Re: McBane Conservation Subdivision Environmental Impact Assessment - **ADDENDUM**
Pittsboro, Chatham County
WR Project #02060411.02

RE: Review Comments – Environmental Impact Assessment for the proposed McBane Conservation Subdivision
JMT Job No. #19-03787-005

McBane Subdivision - Fragmentation Map

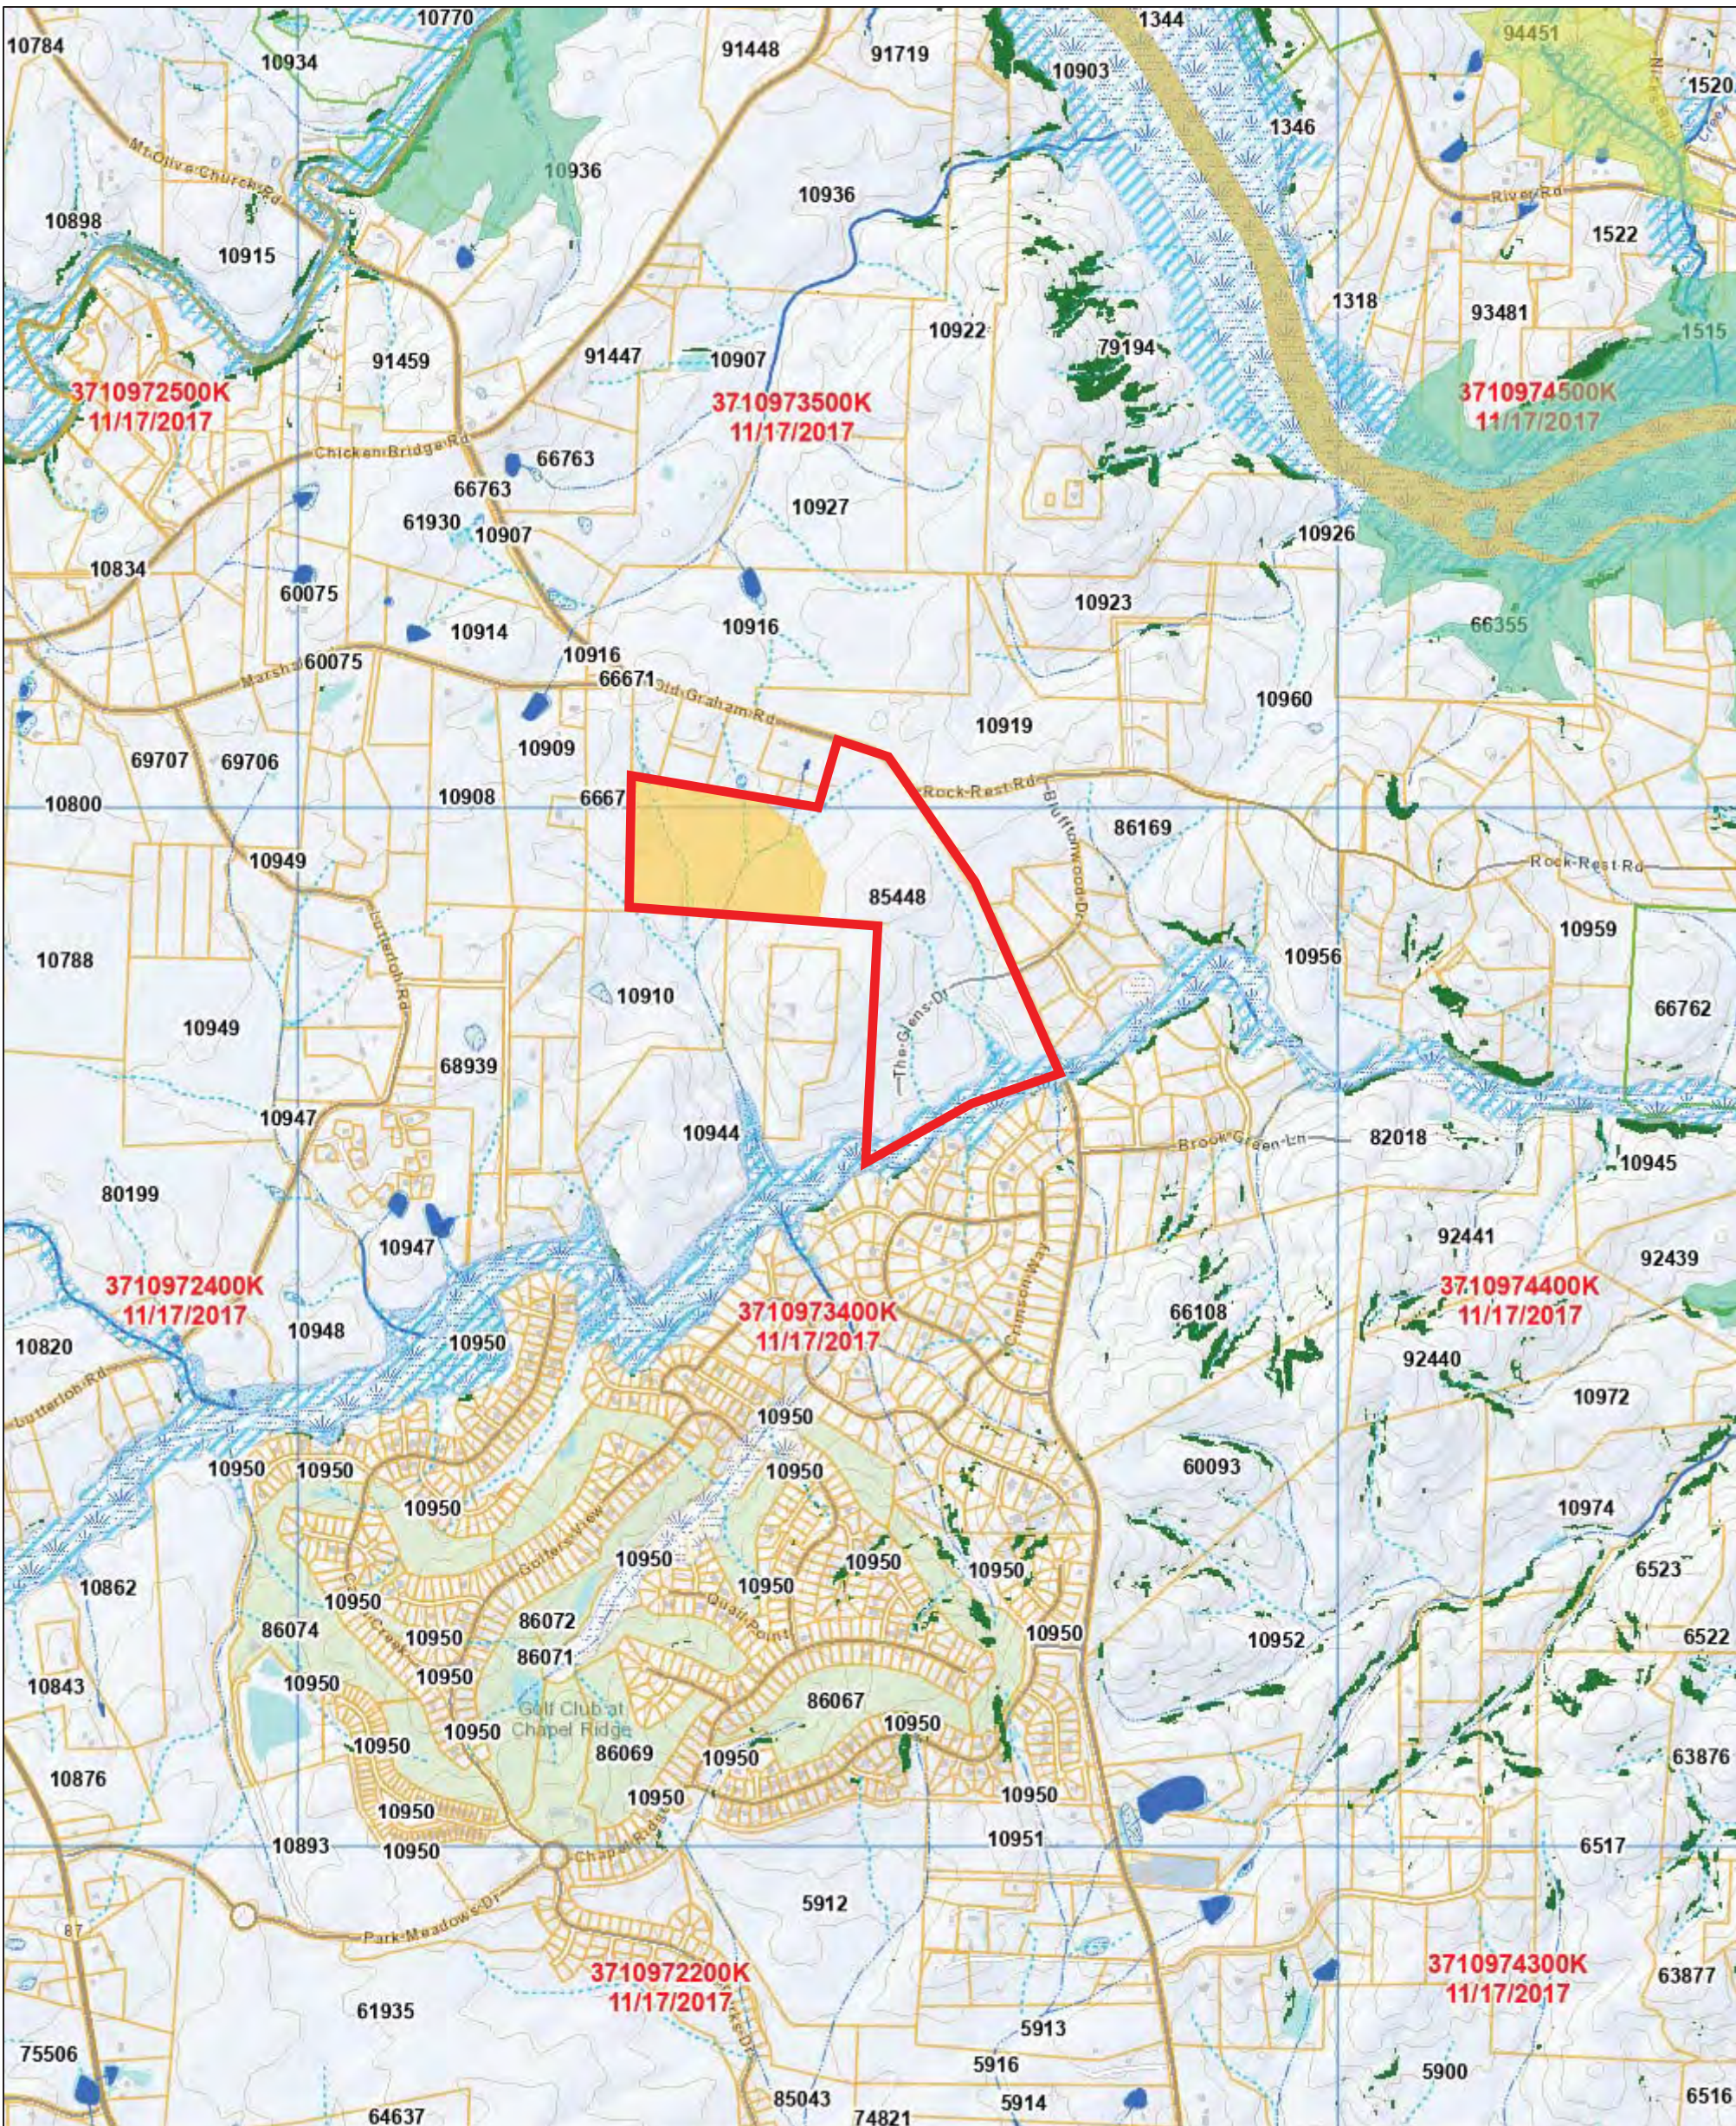
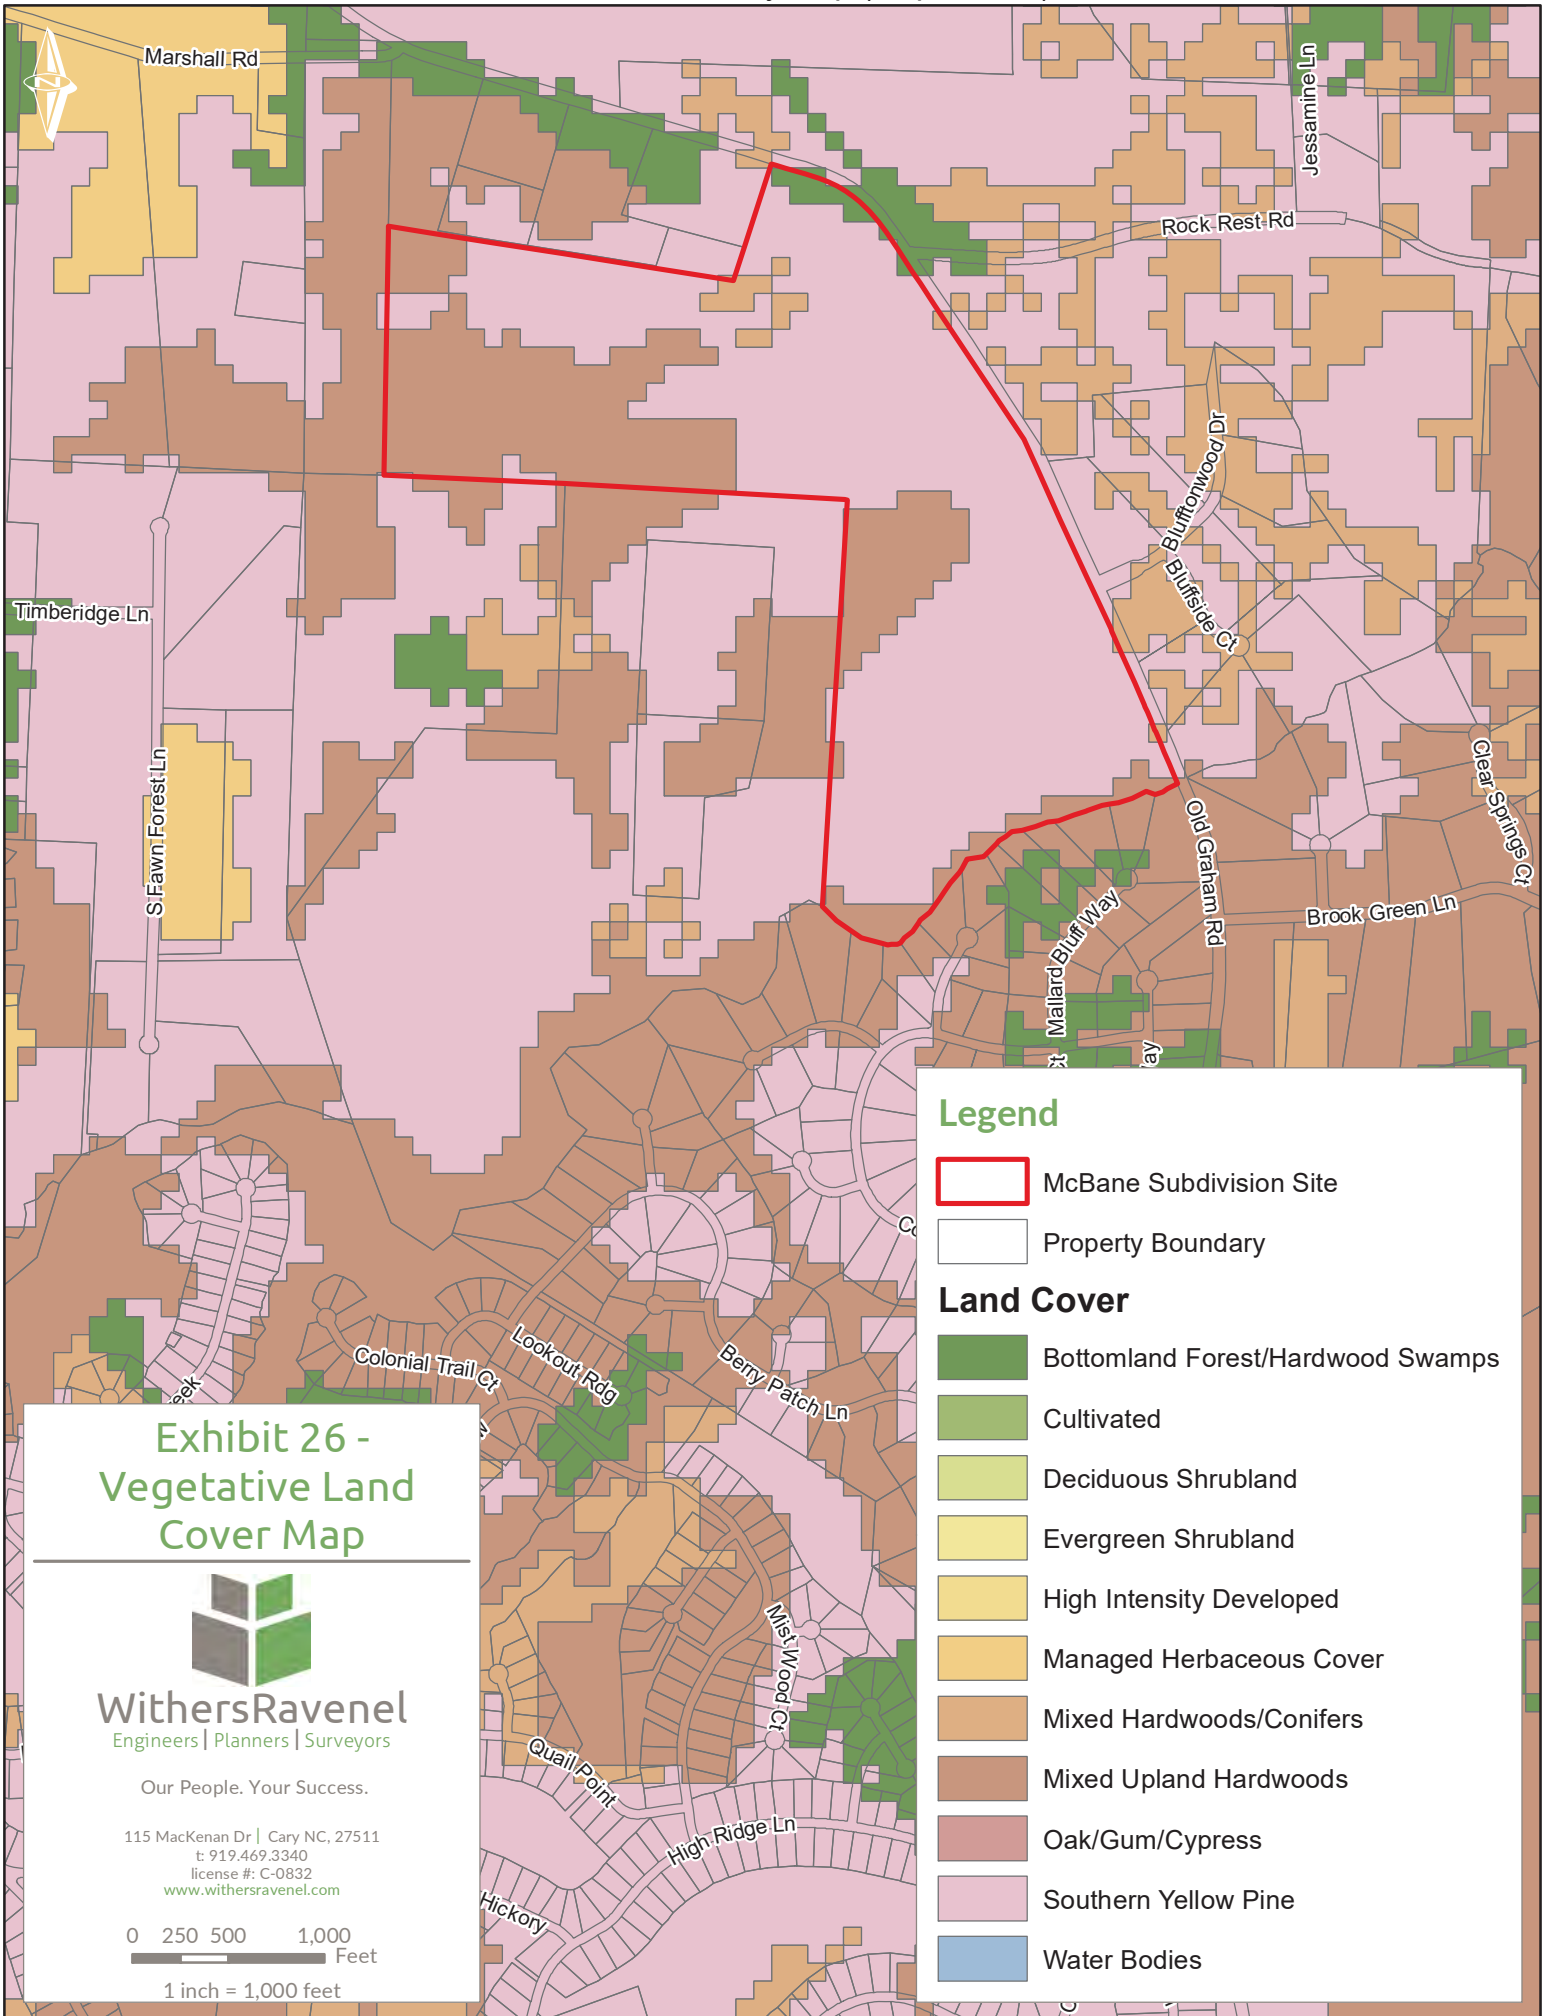
Reviewer Comment: Included. However, the Fragmentation Map (pdf page 137) that was included does not include parcels, floodplains, streams, lakes, ponds, seeps, springs, and wetlands, or steep slope areas as required under the Chatham County Conservation Subdivision Guidelines for Conservation Space Selection. Also, the On-site Inventory Map as required under the Chatham County Conservation Subdivision Guidelines for Conservation Space Selection is not included. These maps will be needed prior to any plat approval.

The following maps have been provided in response to this comment.

- Fragmentation Map (Revised)
- On-Site Inventory Map (Maps 1-6)

ON-SITE INVENTORY MAP (MAP #2 OF 6)

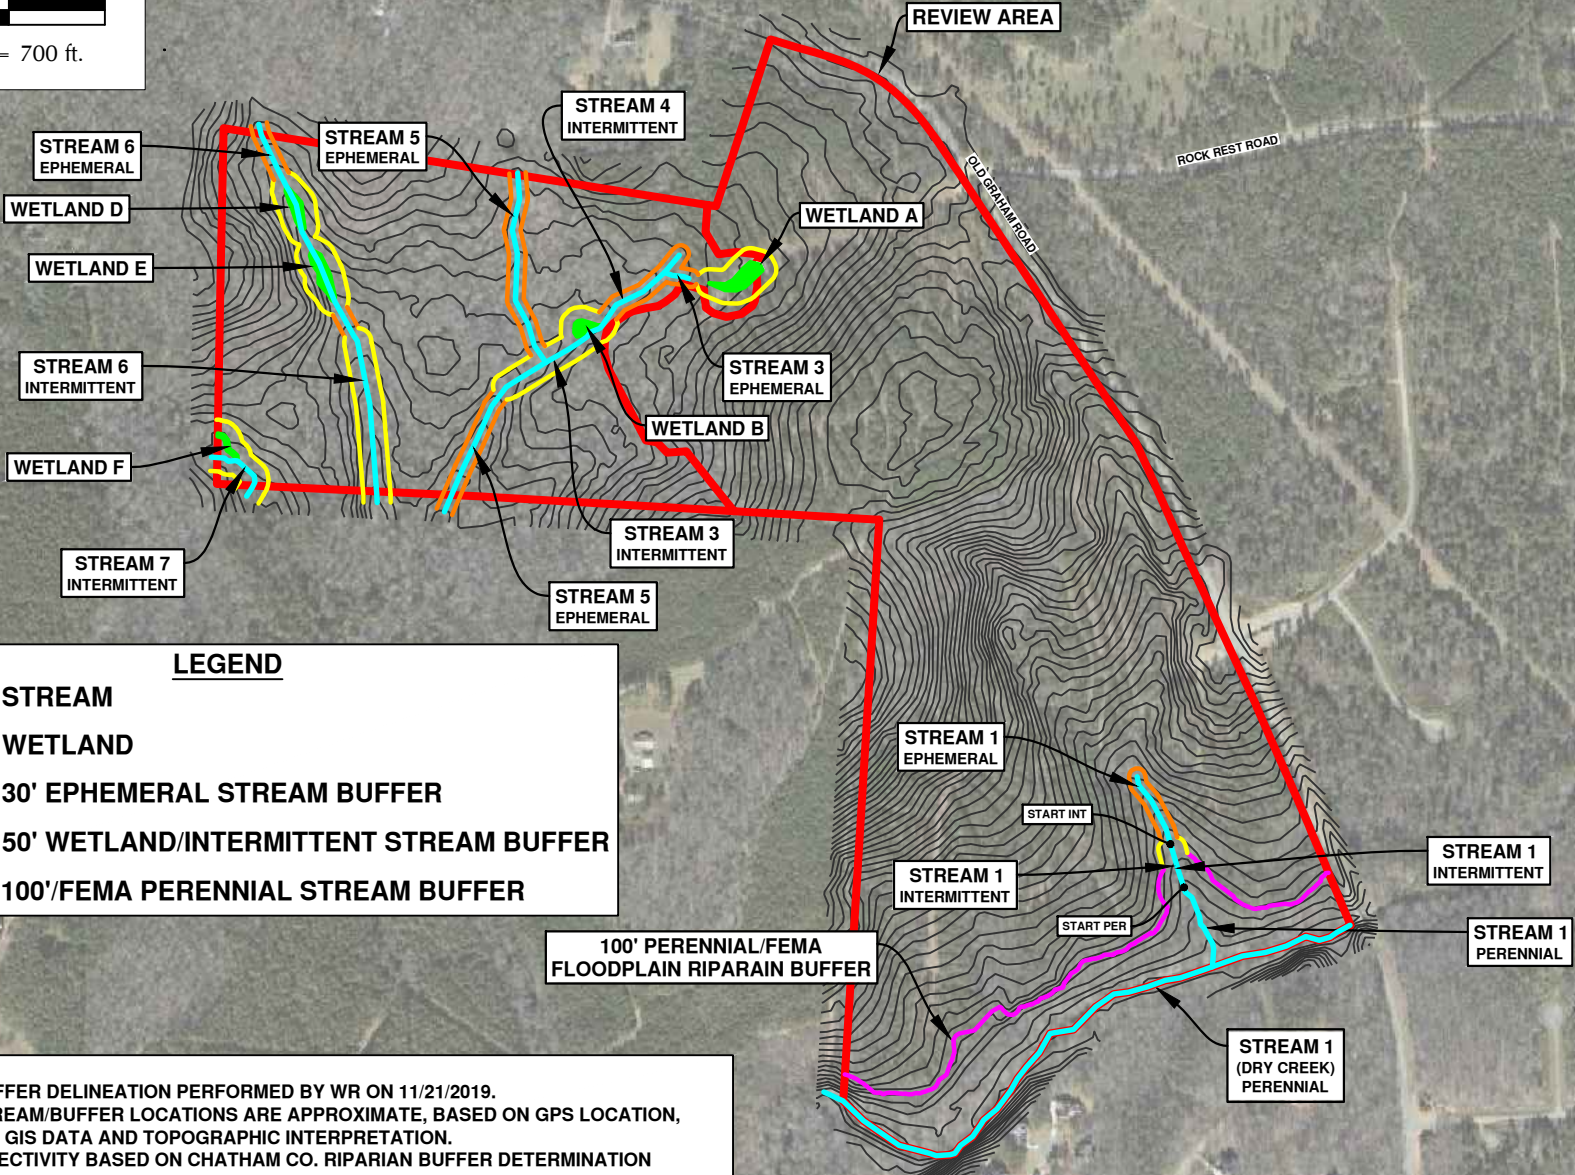
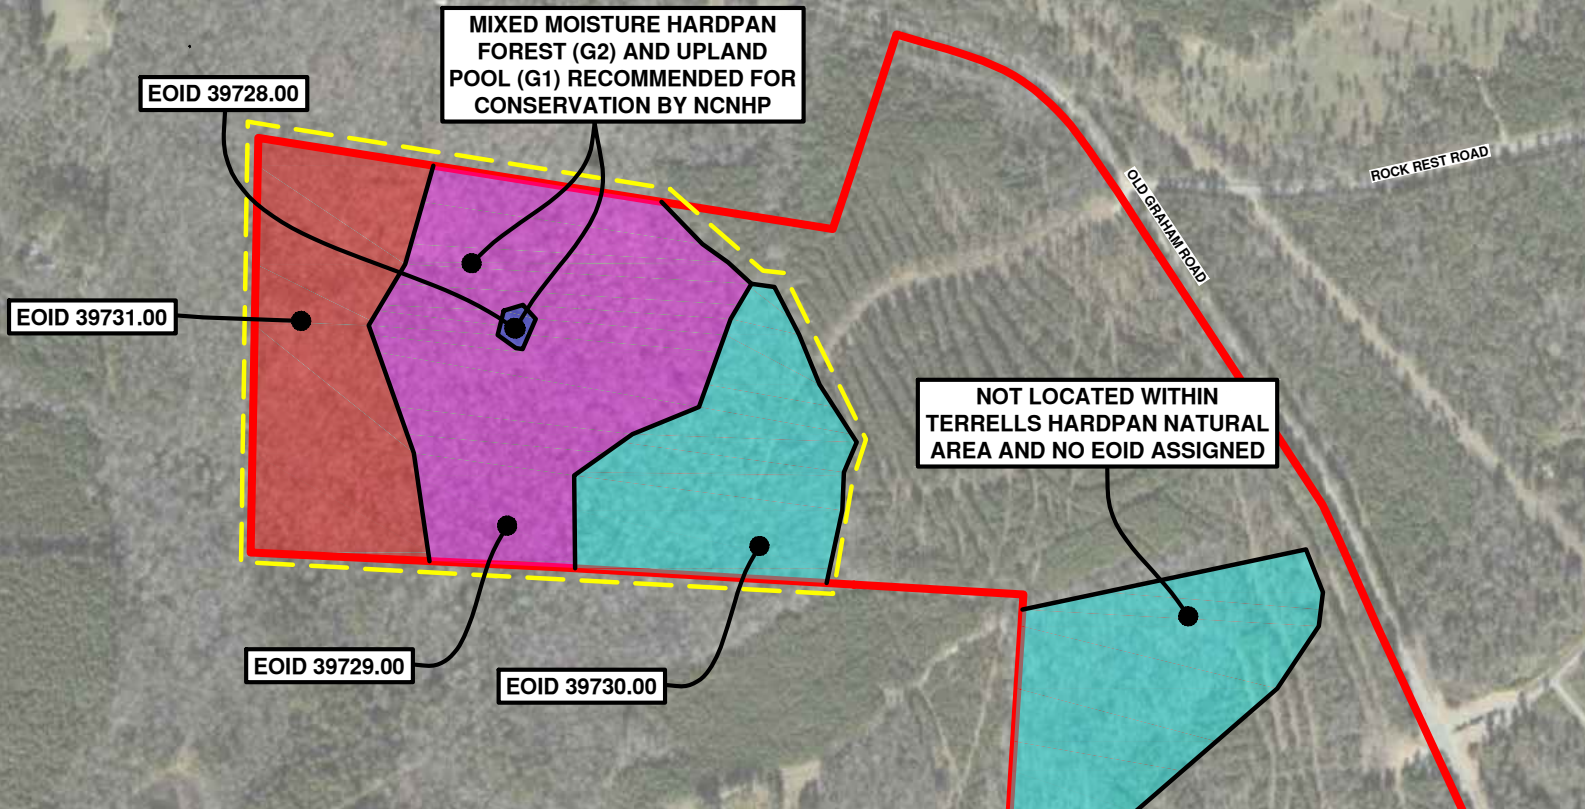
- *Comment: A jurisdictional waters delineation within the northern conservation area has not been completed.*

Reviewer Comment: Included. However, the EIA states that a formal delineation within the northern conservation area will be needed to avoid impacts to wetlands and streams for rustic trails. Ephemeral streams and buffers jurisdictional to the county are shown on Exhibit 14 but not shown on Exhibit 5.

As specified in Section 4.4 – Existing Natural Resources of the EIA, a formal delineation and USACE approval was not originally completed within the northern conservation area because at the time of the delineation there was no proposed disturbance within this area and the inclusion of rustic trails was added later. After conversations with Chatham County, WithersRavenel completed a delineation of the wetlands, streams, and riparian buffers within the northern conservation area.

Upon completion of the delineation, WithersRavenel submitted a request for update of the previously issued Jurisdictional Determination which included the delineation within the northern conservation area. In an email dated 4/29/2021, James Lastinger with the USACE specified that the updated delineation for the entire tract has been verified by the USACE (SAW-2020-01202). Therefore, the delineation for the entire project tract has been verified by the USACE. A copy of the USACE email has been provided as an attachment to this addendum.

The wetlands, streams and riparian buffers are depicted in the On-Site Inventory Map (Map #5 of 6).
